**Storm Surge  
Technical Evaluation Report  
Seabrook Station  
Hazard Reevaluation Review**

**March 2017**

## **TECHNICAL EVALUATION REPORT: SEABROOK STATION**

### **STORM SURGE**

**Figure 1** Historical Hurricane Tracks within 100 mile Radius of Seabrook  
(Source: FHRR, Figure 4-24)

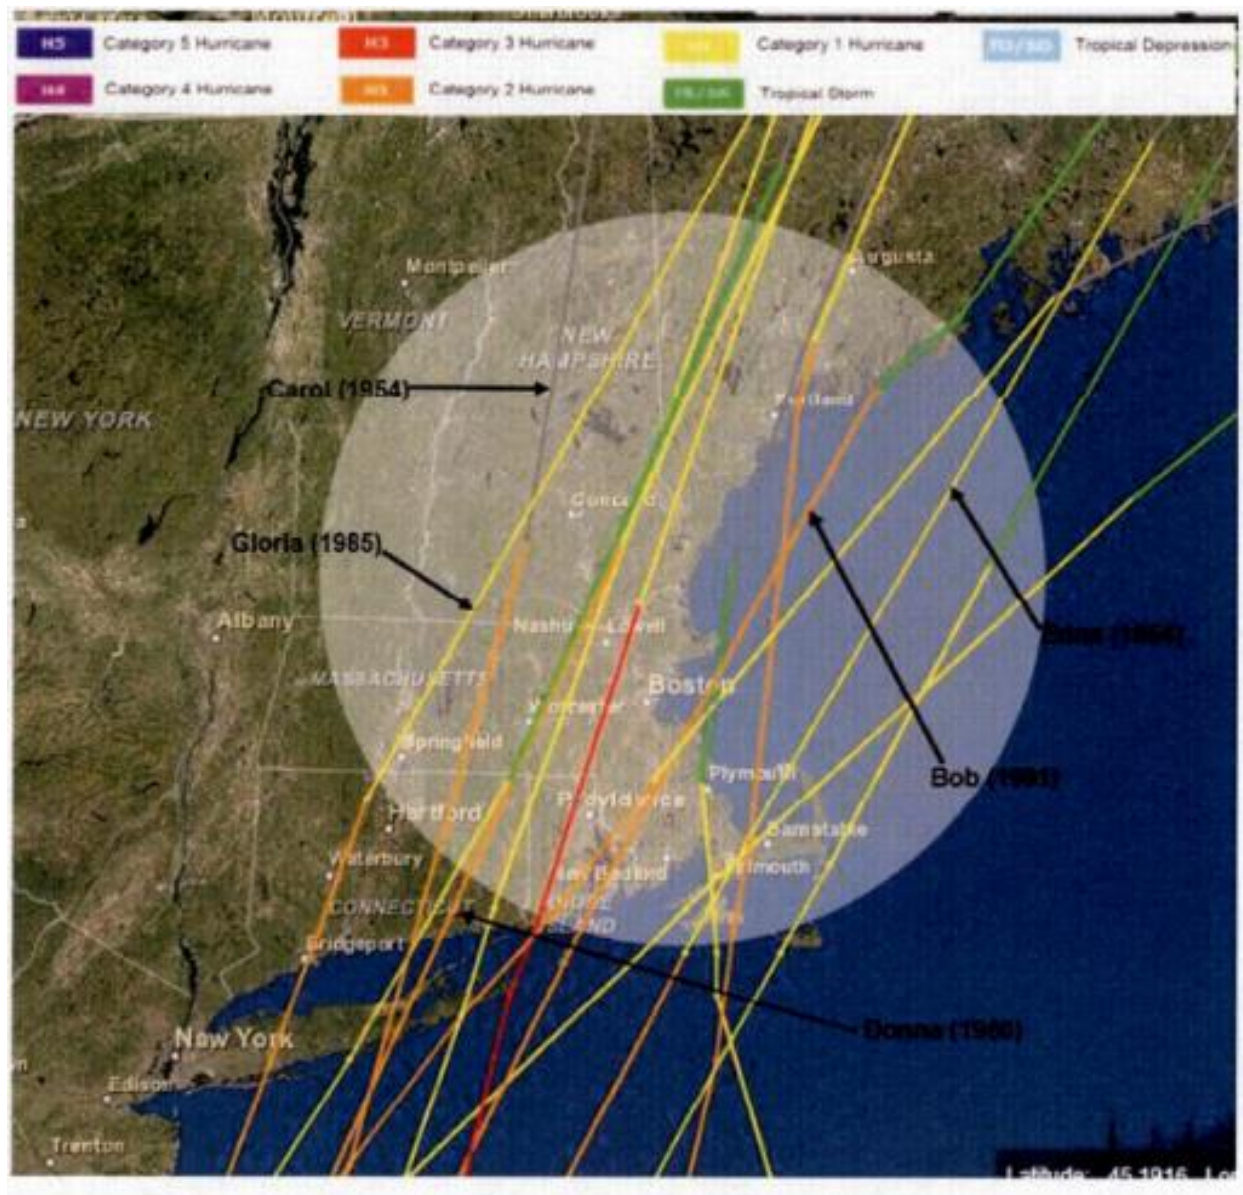
NextEra performed a wide and exhaustive search of historical storm and surge data. NextEra identified and adequately described all relevant storms and surges.

**Figure 7** Delft3D Simulated and Observed Time Series Storm Surge Comparison at Newport (RI) during Hurricane Bob (Source: FHRR, Figure 4-27)

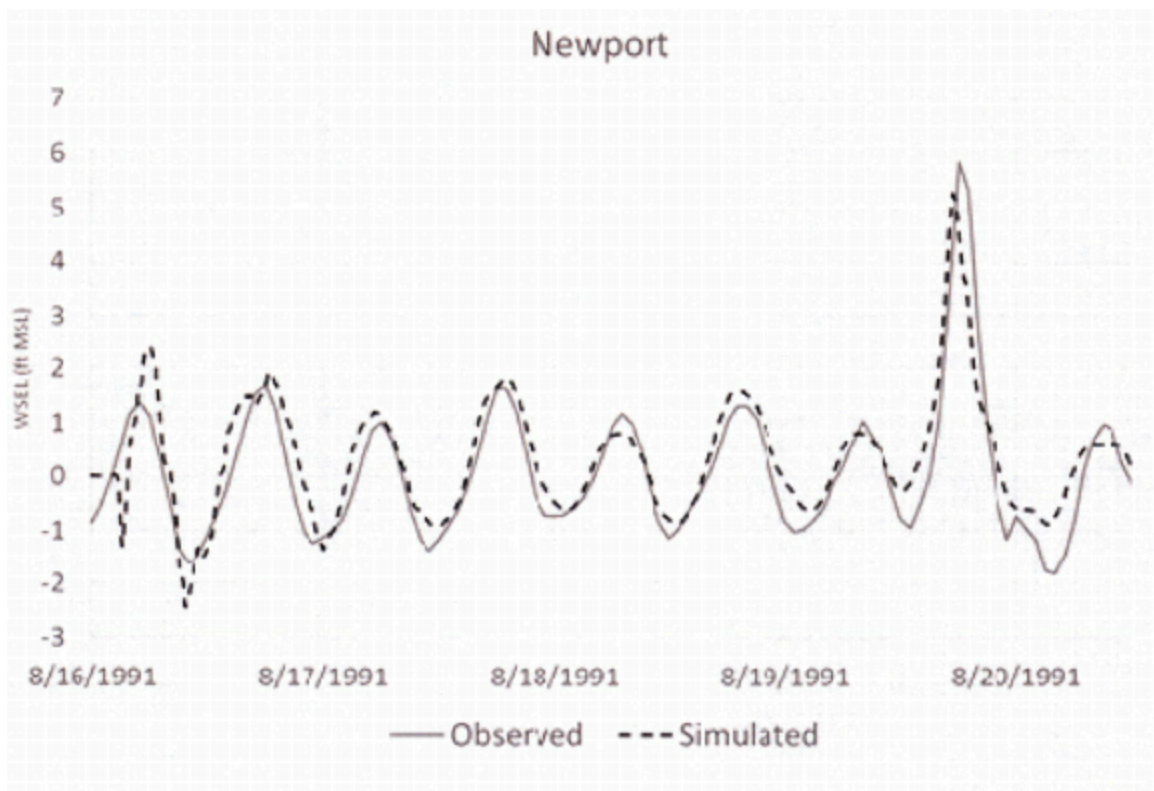
NextEra's model-predicted high water levels reasonably approximated observed levels and present an acceptable validation of the models at select locations. NextEra did not provide indications on model performance near the Seabrook site; due to a lack of measured high storm surge levels near the site during historical tropical or extra-tropical storms.

**Figure 8** Storm Tracks for Top Three Storms in the Independent Analysis Water Levels

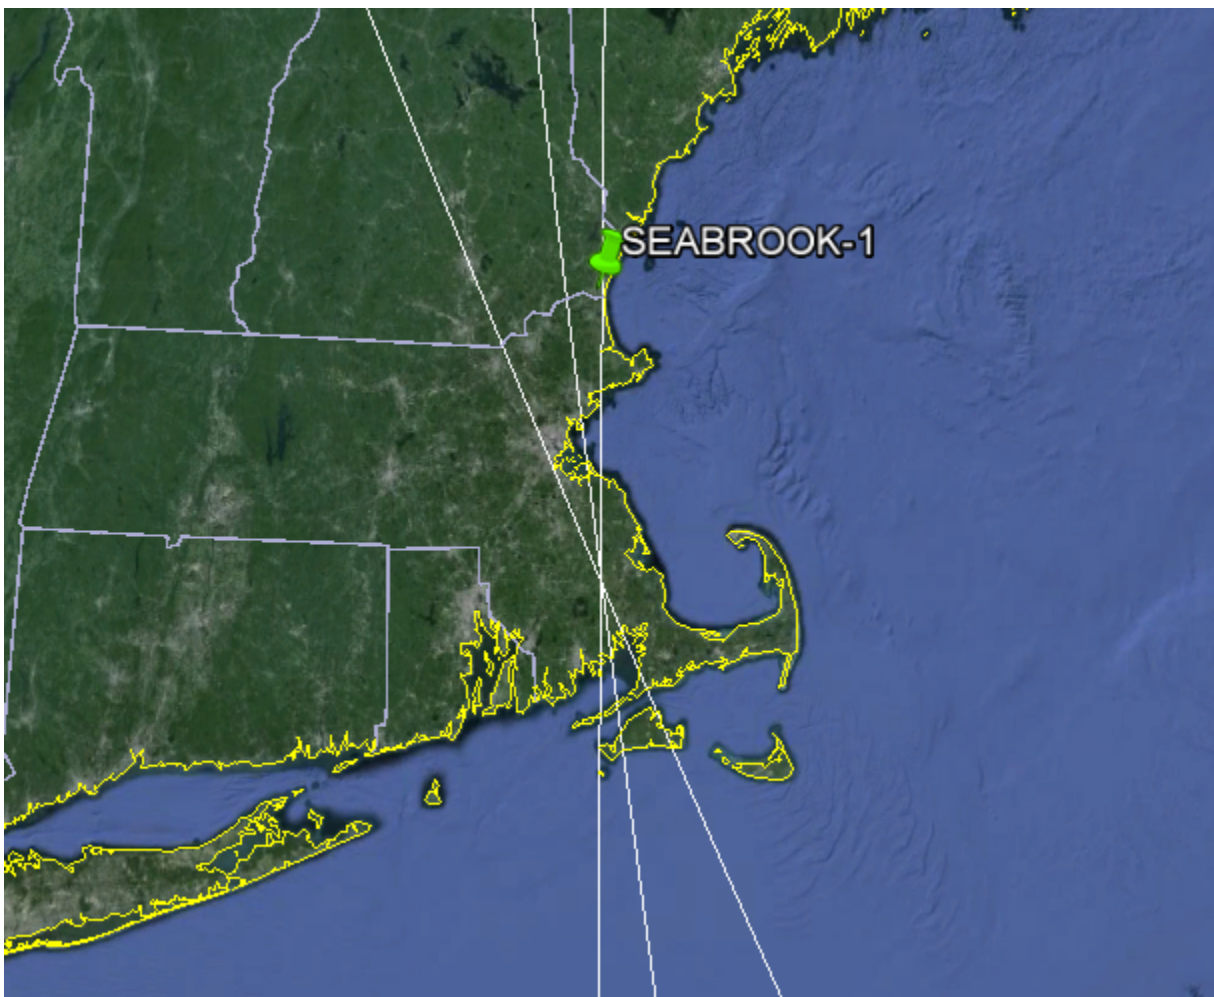
The results from the independent simulations with the PMI forcing allow comparison of the FHRR PMSS water levels. Table 20 presents details of the final three independent simulations with comparisons to the FHRR PMSS water levels for the Seabrook site. Figure 8 shows the tracks for the final three independent simulations.

Table 20 contains a summary of the revised FHRR PMH water levels with information listed for antecedent water level, stillwater level, wave conditions, and total water level including wave runup. The FHRR PMH water levels show a stillwater level of 17.8 NAVD88-ft including the 4 ft sensitivity margin and a total water level of 23.4 ft-NAVD88 at the seawall away from the structures. The three right hand columns in Table 20 show results from the final three Taylor Engineering staff independent SWAN+ADCIRC simulations that applied PMH-level wind forcing at the site.<sup>1</sup> The Taylor Engineering independent simulations show stillwater levels near the site seawall that range from 17.8 to 20.6 ft-NAVD88; near the revised FHRR stillwater levels. The Taylor Engineering independent simulation results show total water levels, including wave runup, near the site that range from 19.6 to 21.3 ft-NAVD88. Notably, the revised FHRR Table 5-1 provides a total water level of 23.4 ft-NAVD88, but states this value occurs near the seawall and should not be deemed equal to the total water level near site structures.

With consideration of all information provided by NextEra in the original and revised FHRR documents, NextEra provided an acceptable PMSS within the revised FHRR.

**Figure 12** Time Series of Wave Overtopping (Source: FHRR, Figure 4-46)

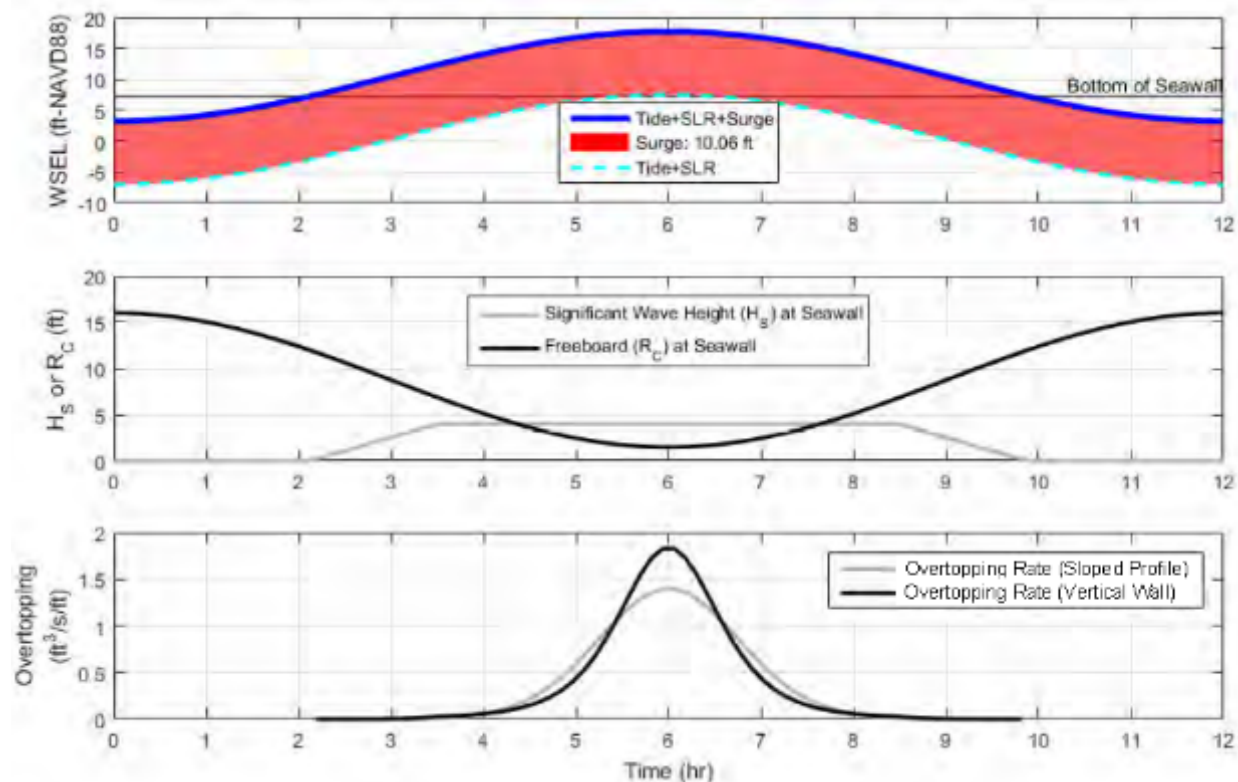
NextEra estimated the duration of surge-induced flood duration from overtopping waves at approximately 4.5 hours (Figure 12).

Based on review of NextEra's Delft3d and overtopping results and the Taylor Engineering's independent simulations, NextEra's estimate of the duration of the flood event is acceptable.
